SUBJECT: Forwards responses to NRC 950901 RAI re GL 95-03,
"Circumferential Cracking of SG Tubes."

Subject: Oconee Nuclear Station Units 1, 2, & 3
Docket Nos. 50-269, 270, 287
Response to Request for Additional Information Concerning Generic Letter
95-03

OCONEE NUCLEAR STATION
RESPONSE TO RAI FOR GL 95-03

Response to Request for Additional Information Regarding Circumferential Cracking of Steam Generator Tubes - Oconee, Unit 1, 2, and 3

FIGURE 1

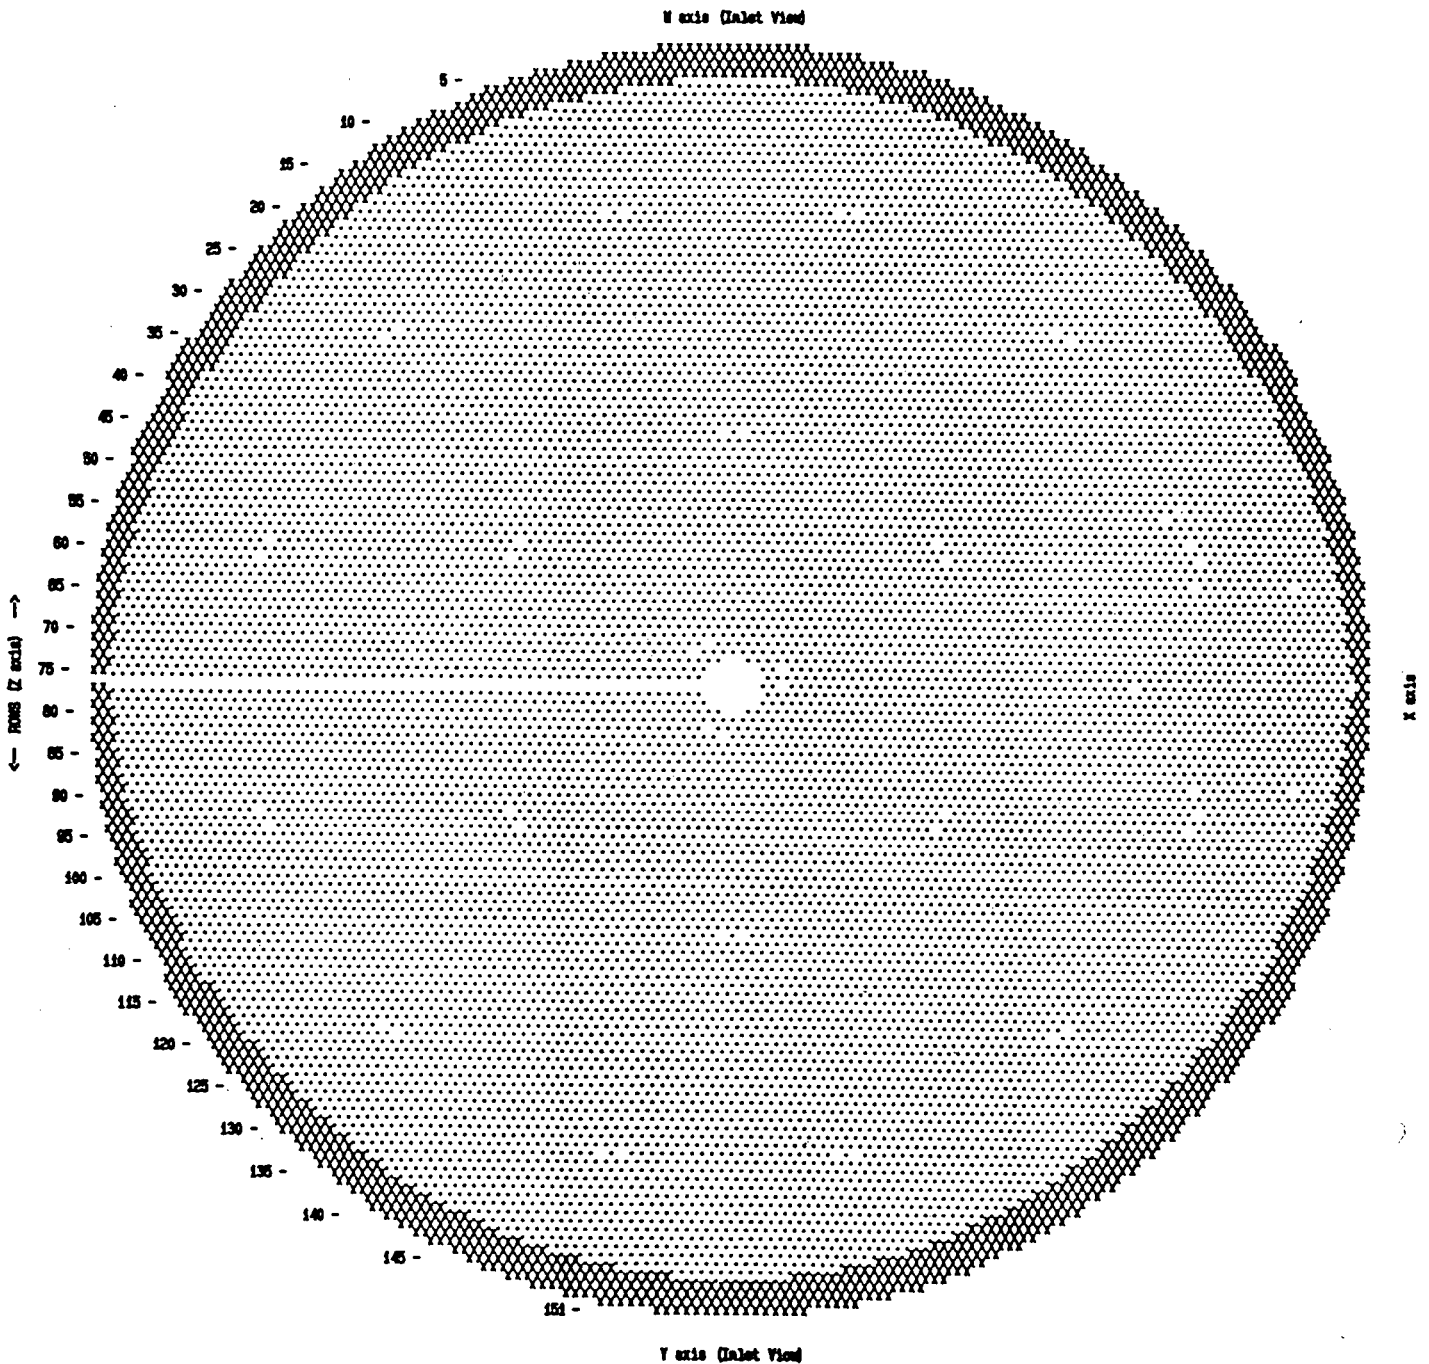
EPRI report NP-6201 indicates that the fifteenth tube support plate contains both broached holes and drilled holes. The drilled holes have been prone to denting. Please clarify whether all of the tube support plates are of the broached hole designs or whether a number of them contain drilled holes. Discuss whether denting has been limited to the drilled hole locations, if applicable, or if it has been observed at other support plate intersections (i.e., broached holes).

1. The B&W generic response indicated that all of the TSP's had broached holes. This information is correct except that there are drilled holes around the periphery of the 15th TSP as shown in figure 1.

As indicated in the question 1 response, the drilled holes are located at the 15th TSP. The denting at TSP's has been limited to broached hole locations.
